Project Submittal Interim Form

Intersection of US 401 at SR 2044 (Ligon Mill Road) and SR 2224 (Mitchell Mill Road) (U-5748 Central)

Subject: **Modification Request for Section 404 Regional General Permit 50, Section 401 Water Quality Certification and Neuse Riparian Buffer Authorization** for Upgrade of an Existing at-grade Intersection of US 401 at SR 2044 (Ligon Mill Road) and SR 2224 (Mitchell Mill Road) to offset Continuous Flow Intersection from the US 401 and Leland Avenue Intersection to the US 401 and Perry Creek Road Intersection in Wake County; TIP Number U-5748. Debit \$570 from WBS Element 50168.1.1.

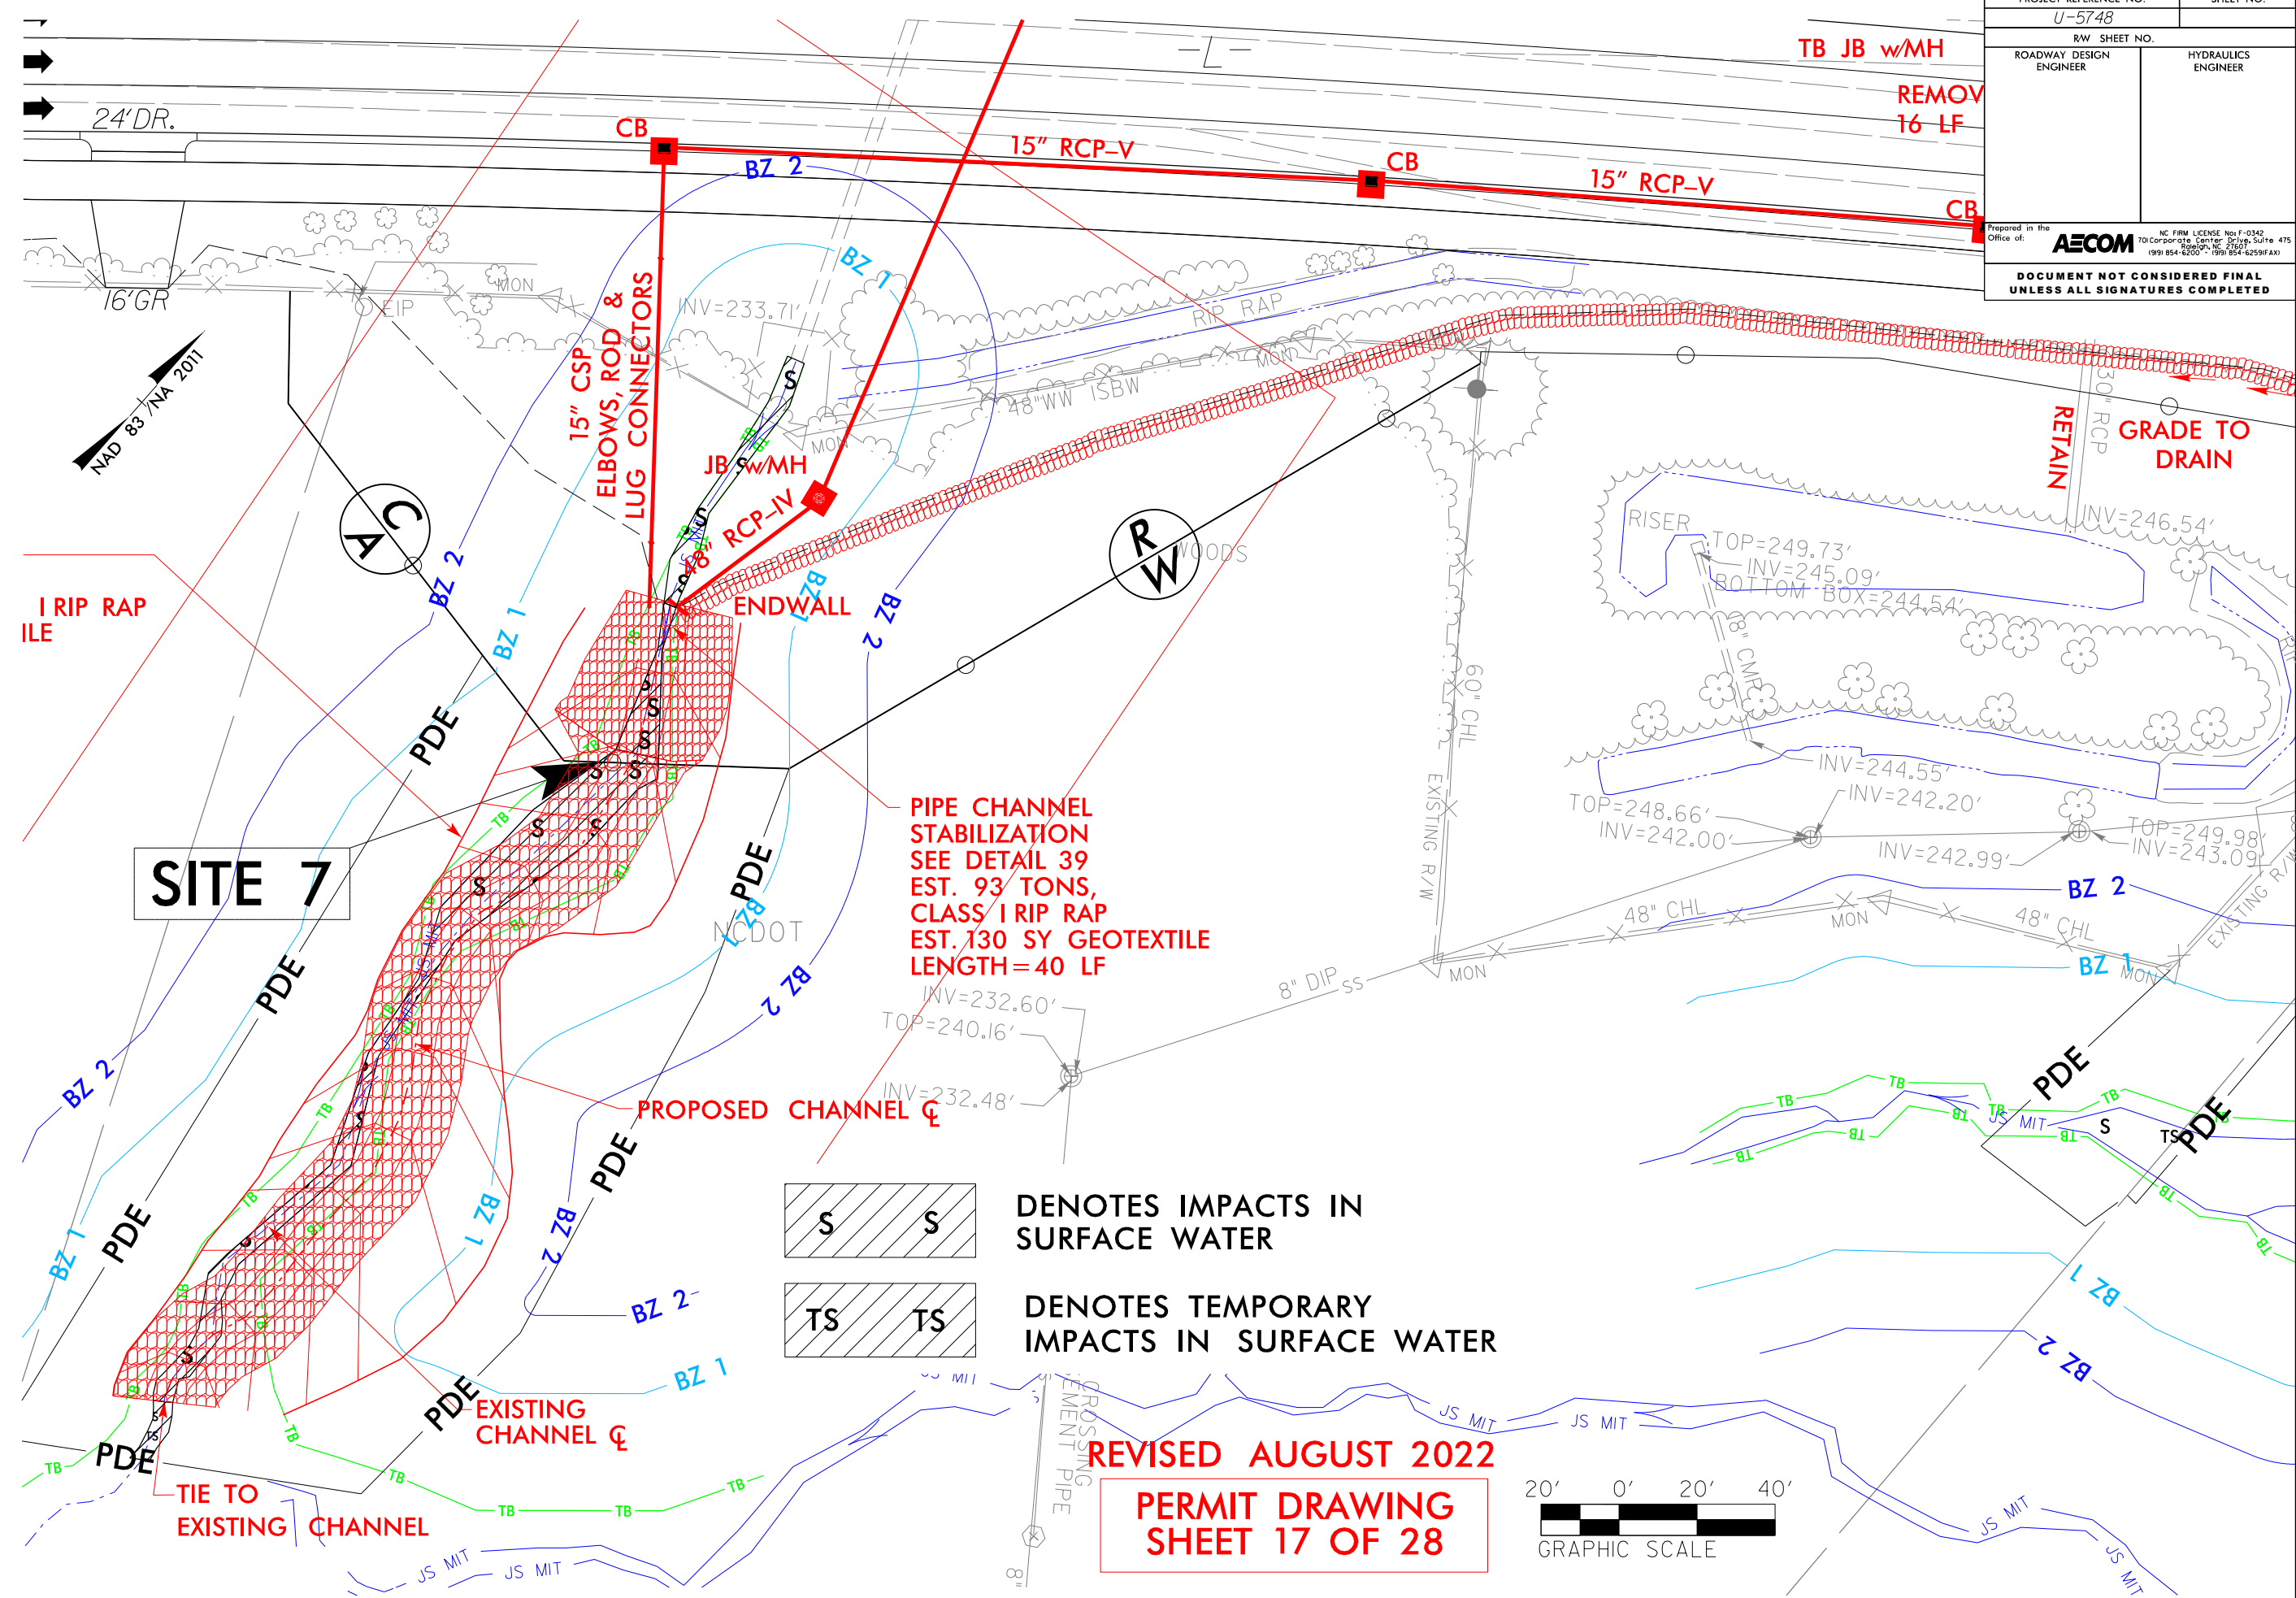
Site 7: Due to constructability concerns, a drainage design revision was required to delete a deep drainage inlet. This revision removed the pipe outlet at Site 13 and instead, directs the water to outlet at Site 7. Due to the poor existing conditions of the channel at Site 7 and the proposed increase in drainage to this area, rip rap channel stabilization is proposed to be added for the length of the degraded channel section. This will result in the following changes:

Site 13: Due to constructability concerns, a drainage design revision was required to delete a deep drainage inlet. This revision removed the pipe outlet at Site 13 and instead, directs the water to outlet at Site 7. This will result in the following changes:

PERMIT DRAWING
SHEET 18 OF 28

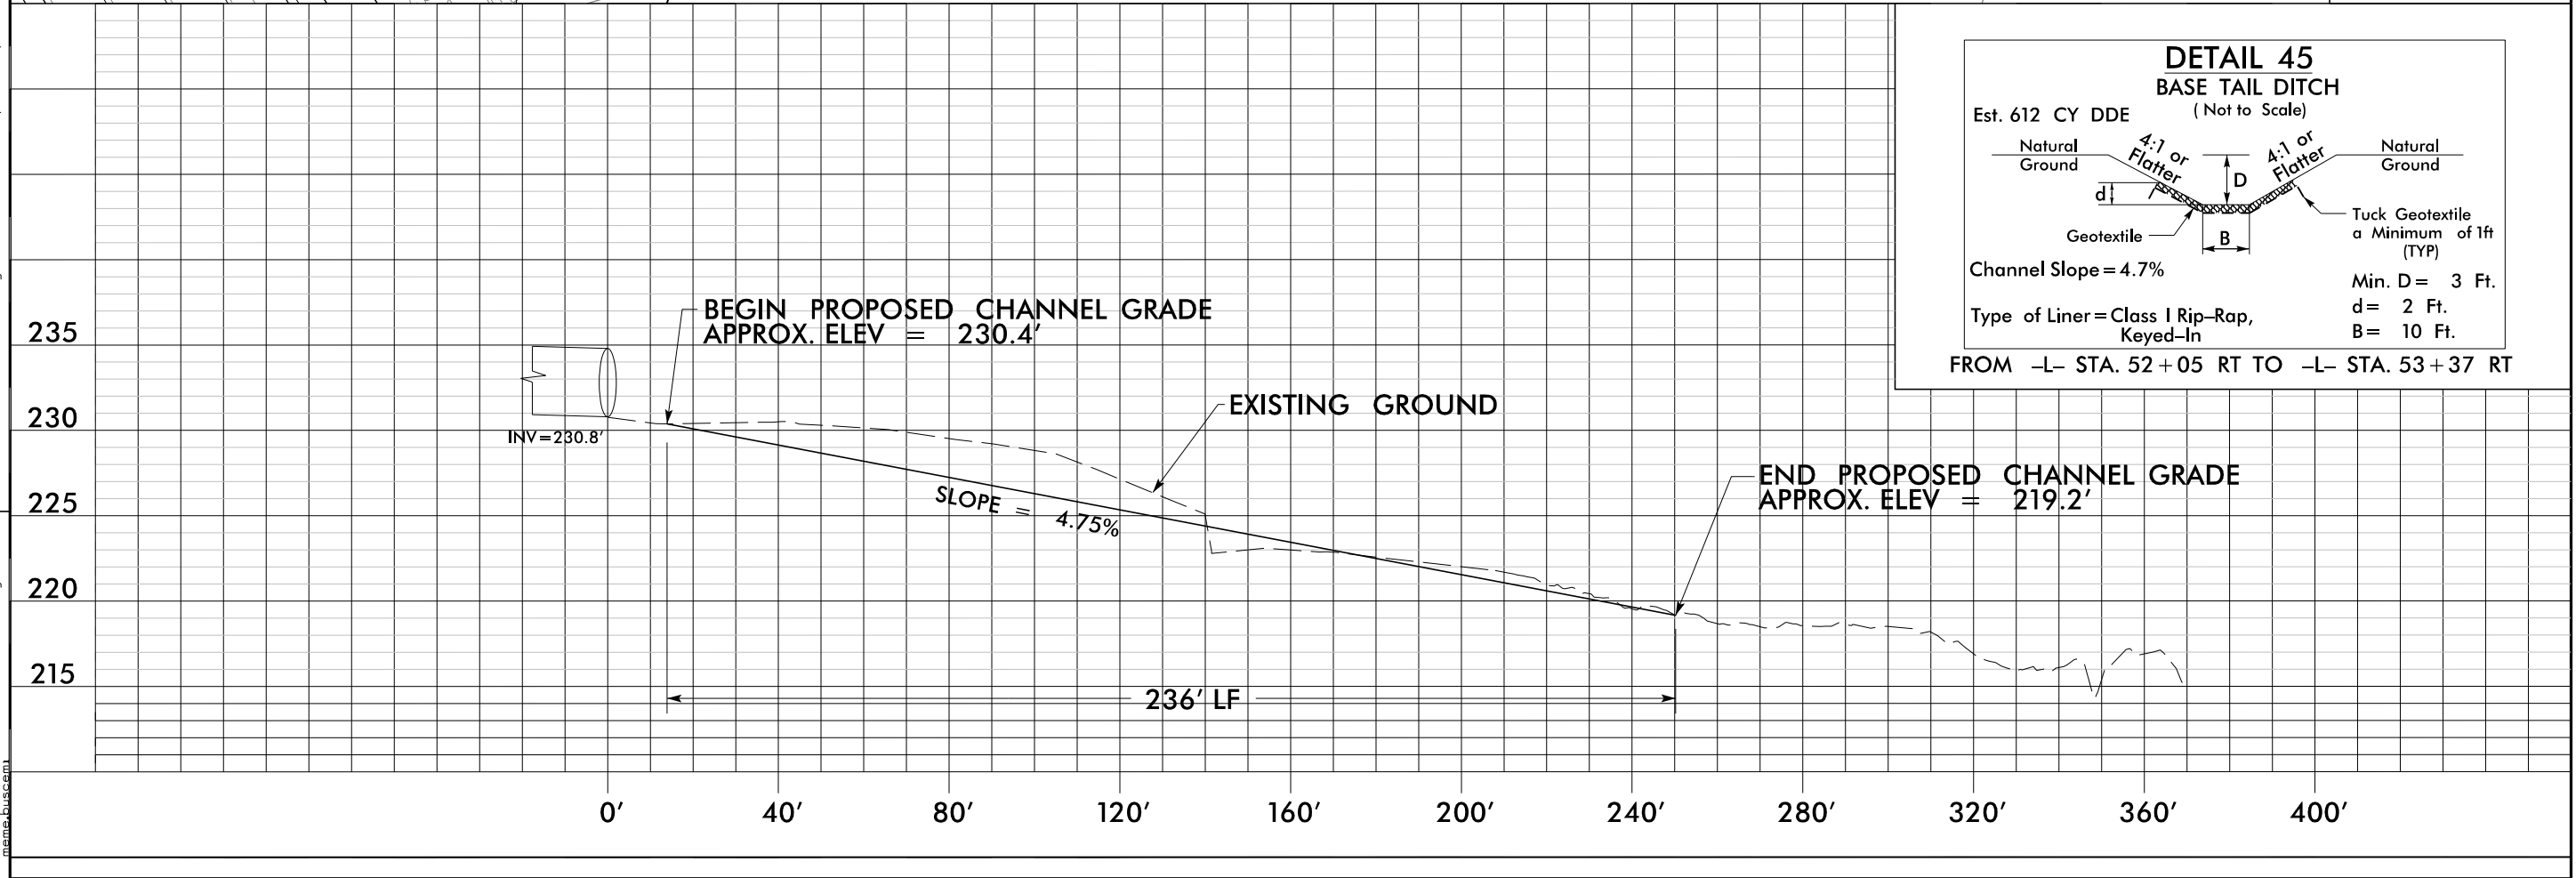
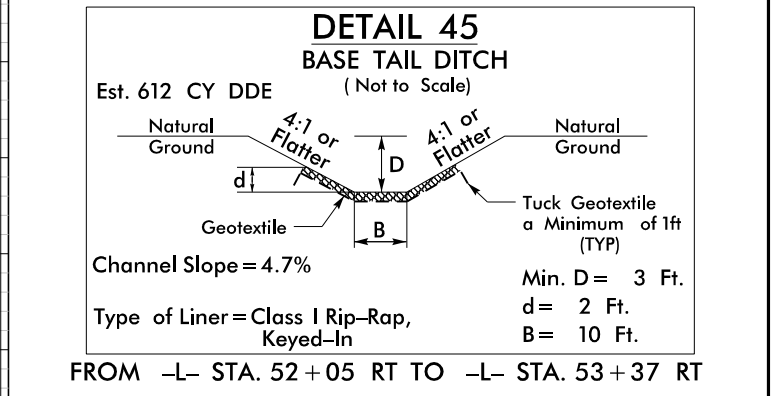
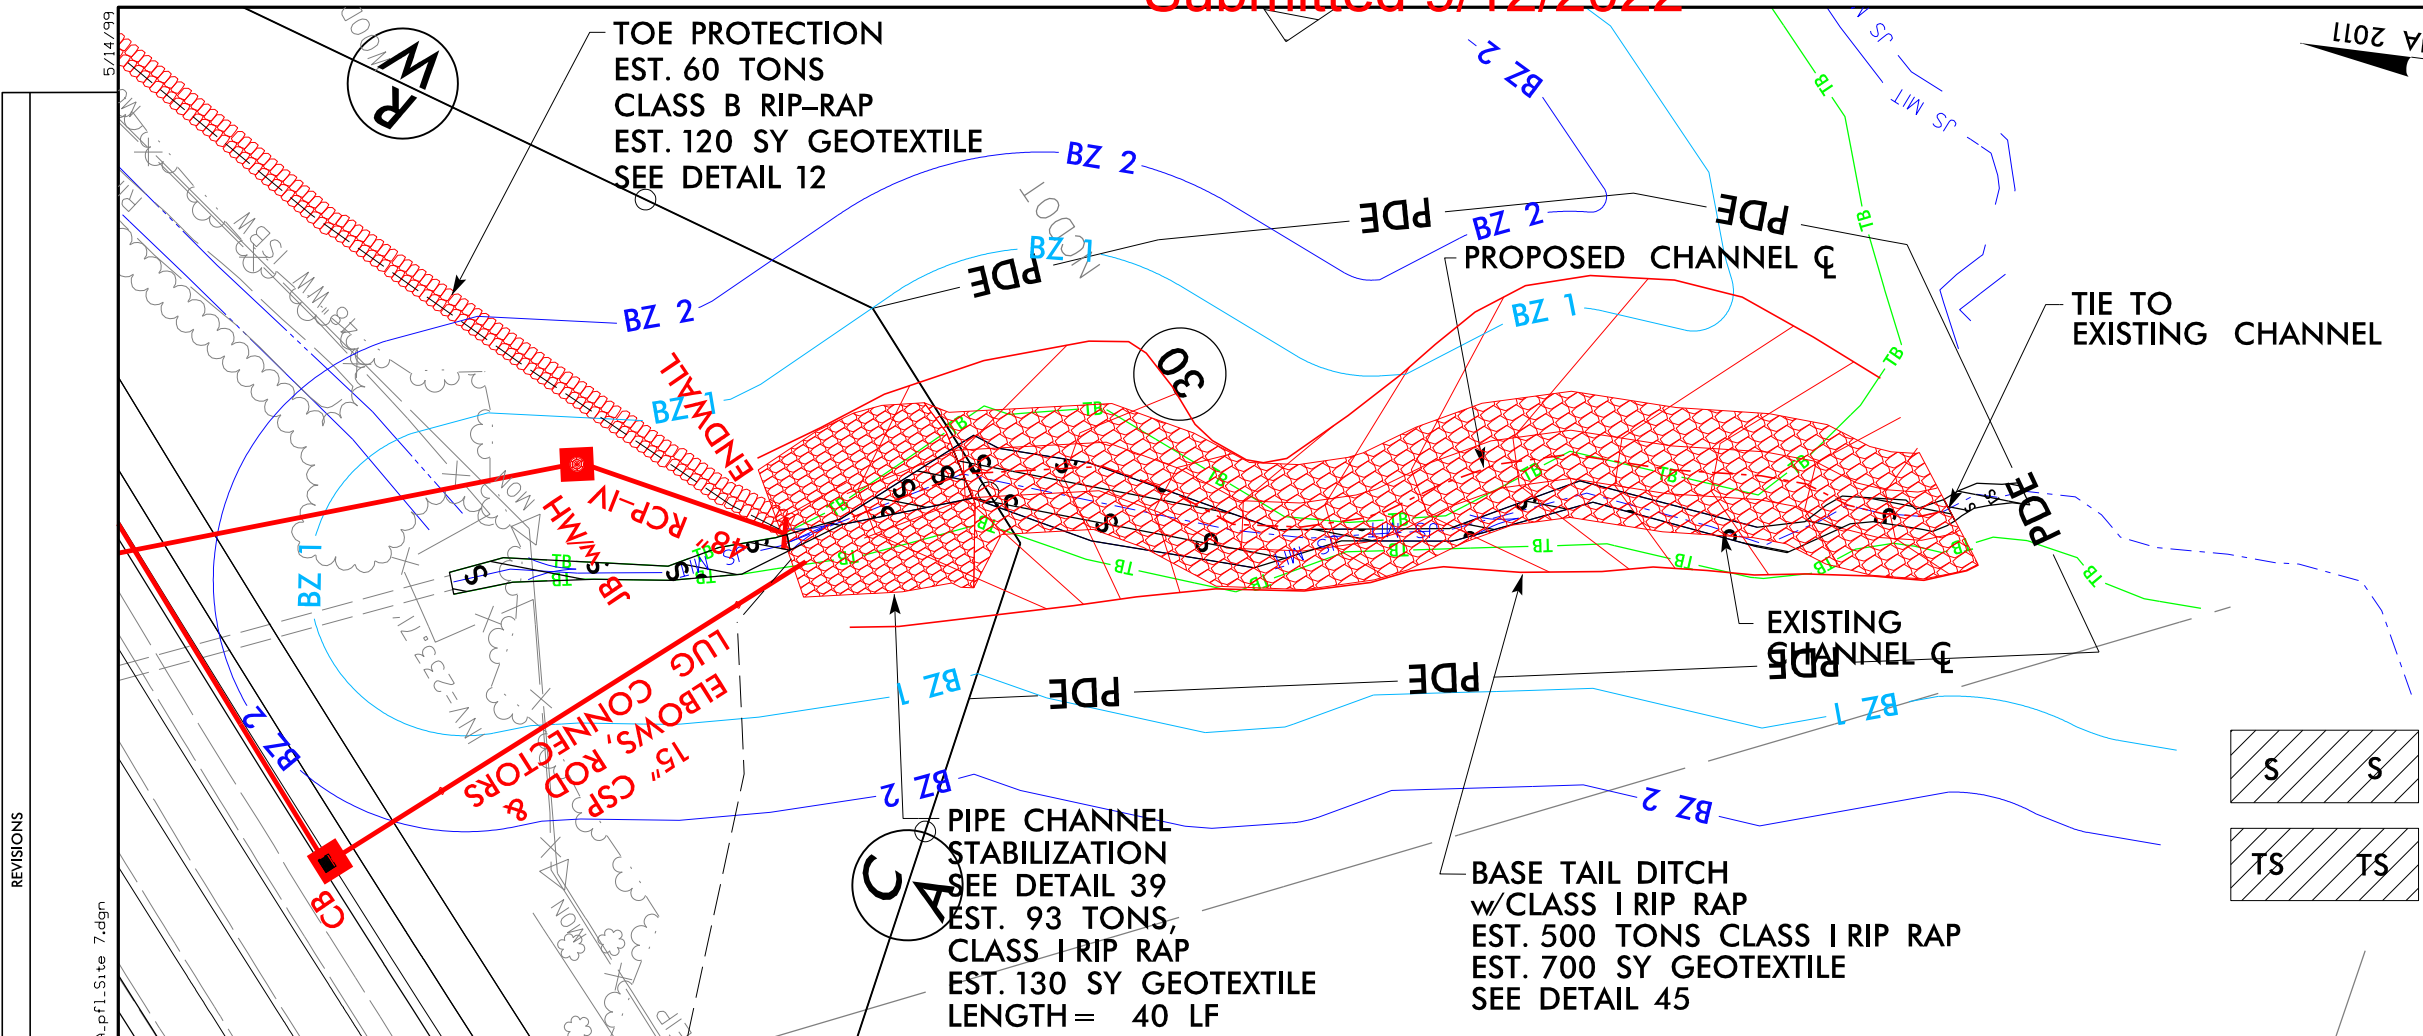
- 213 linear feet increase in permanent stream impacts
- 14 linear feet increase in temporary stream impacts
- Increase of 12,526 sq ft Buffer Zone 1 impacts
- Increase of 2,541 sq ft Buffer Zone 2 impacts

In order to eliminate the deep drainage inlet and new pipe bore extending through an existing reinforced fill slope, both of which include constructability and future maintenance issues, drainage was revised to outlet at Permit Site 7; stream SE. The original outlet stabilization footprint at Permit Site 7 was determined to be insufficient for the increased drainage to this outlet. Further, the option of providing a larger outlet stabilization structure (i.e. energy dissipator) within the existing footprint was evaluated, however, the current condition of the channel below the original footprint was also determined to have existing head cuts and eroded slopes, which would be worsened by the increased flow to this area. Calculations show that the increase in flow to this already eroded channel would result in a design velocity and shear stress too high for a vegetated channel. Therefore, the channel was determined to need rip rap stabilization. The length of rip rap stabilization needed was limited to the extent possible where the channel below these improvements would be able to remain stable given the increased flow to this area. The outlet of this channel stabilization was located at a point where the existing channel fans out further downstream and allows for a milder slope and wider base, providing better long-term stability. The rip rap channel stabilization includes countersunk rip rap in the flow line to facilitate eventual sediment loading and stream naturalization.
